Reasons for Decision

Preliminary Screener:	MVLWB
Reference/File Number:	MV2011L2-0004
Applicant:	De Beers Canada Inc.
Project:	Snap Lake Diamond Mine, NT

April 4, 2012

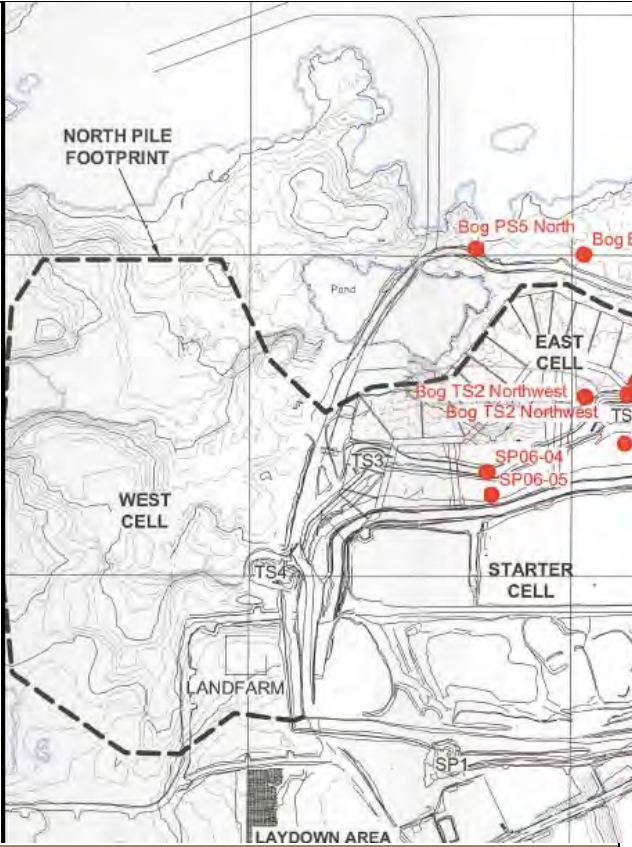
<p>AANDC understands that the board is considering IL6 ditch and would suggest that if approved an additional SNP station be considered for the ditch (spilled water catchment).</p> <p>Recommendation:</p> <p>Consider including a SNP station for the IL6 ditch.</p>	<p>De Beers has agreed to establish a seepage monitoring point for the duration of construction of the IL6 ditch between the ditch and the lake.</p>	<p>The additional station can be added at a later date when there is more evidence to do so.</p> <p>Board Decision: No changes to SNP at this time.</p>	
	<p>Maps for SNP stations are needed for further discussion</p>		<p>Maps will be added to the SNP that are already being used in the monthly report.</p>	
<p><u>SNP 02-10</u> SNP 02-10 refers to any other points where observable</p>	<p>Within the last 14 months there were 8 spills within the North Pile footprint, and more</p>	<p>De Beers agrees with this</p>	<p>This was not presented in an intervention or as part of the</p>
